TECHNICAL BULLETIN INDEX
Sorted by Bulletin Number
06/25/86

DATE: January 16, 1985
REVISION DATE: February 13, 1985
BULLETIN NO.: 6000:1
PRODUCT: 26-6021/2 (Tandy 6000)
26-6014 (8 MHz CPU upgrade kit)
SUBASSEMBLY: 8 MHz 68000 CPU board

SOLDER SIDE (LAYER 4)

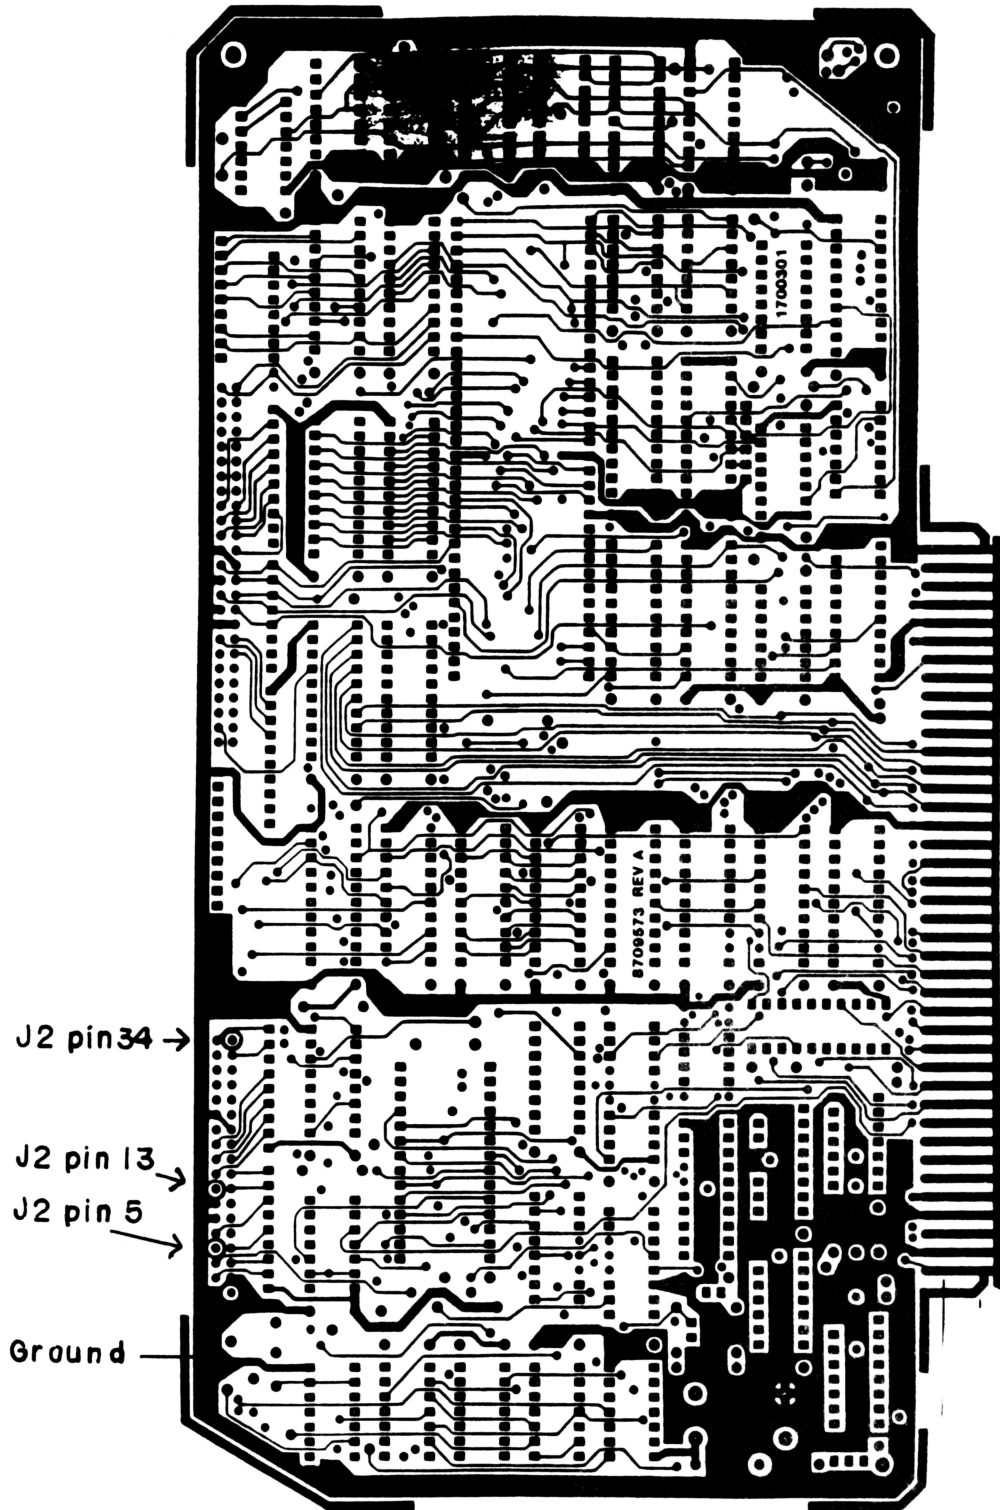
Due to an error in the artwork on early revision (Revision A) boards, a modification to insure good ground connections between the 68000 CPU board and associated memory boards is required.

Using wire wrap wire, install the following jumpers on the solder side of the 68000 CPU board:

- (1) Jumper J2, pin 5 to ground.
- (2) Jumper J2, pin 13 to ground.
- (3) Jumper J2, pin 34 to ground.

Ground may be found at the feed-throughs on the ground plane near J2 on the solder side on the board.

Figure 1

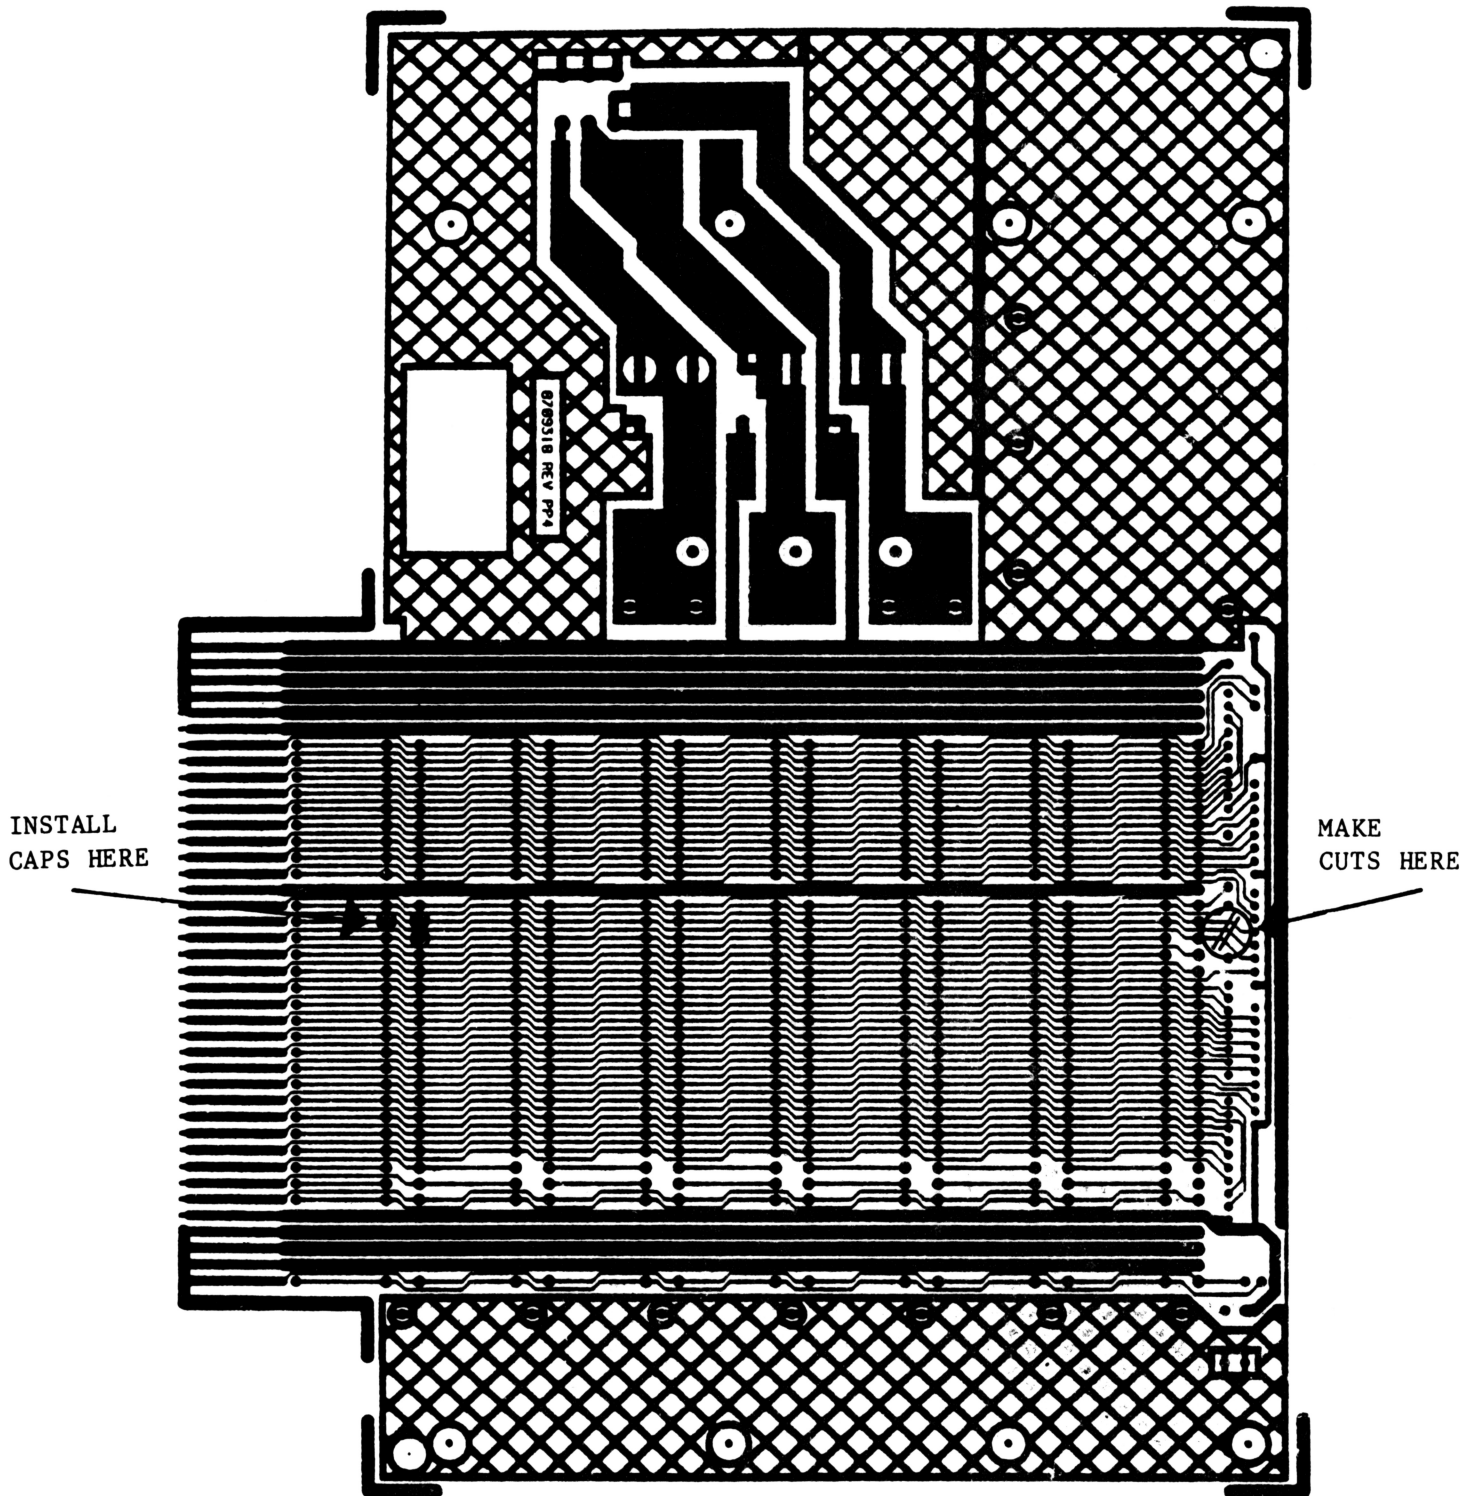
To prevent bus errors, three traces need to be cut away from a resistor pack and three capacitors need to be installed on the card cage mother board.

Due to a change in the silk-screening for the resistor packs on the card cage mother board, the actual pin to be cut on the resistor packs will be different for certain board revision levels.

On mother boards of revision levels prior to Rev. B, pins 3, 4, and 5 on resistor pack R6 need to be cut.

On mother boards of revision level Rev. B or later, pins 4, 5, and 6 on resistor pack R6 need to be cut.

On boards of all revision levels, three (3) 220 pf caps should be jumpered from pins 44, 45, and 46 to ground on the bottom-most connector. These pins correspond to the traces cut on the resistor pack R6. See Figure 1 for clarification. The capacitors needed for this modification may be ordered as:

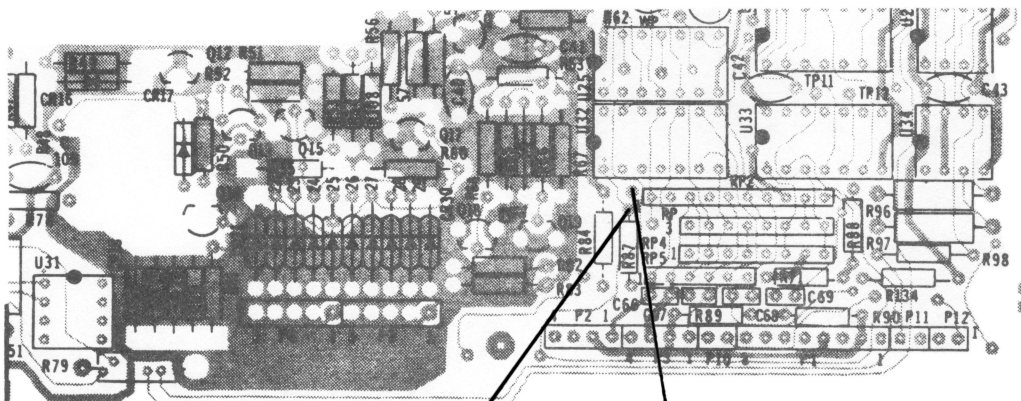
DISCUSSION: An addressing problem exists with Tandy 6000s due to slow multiplexers on the main logic board. U52, U53, and U79, three 74LS157 IC's, are misaddressing memory causing BOOT ERROR MF.

PROCEDURE: Remove the three 74LS157 IC's and replace them with 74S157 IC's or 74F157 IC's. The part numbers for these IC's are below.

74S157 MX-6112 26-5103
74F157 MX-2135 26-6014/5 or 26-6021/2
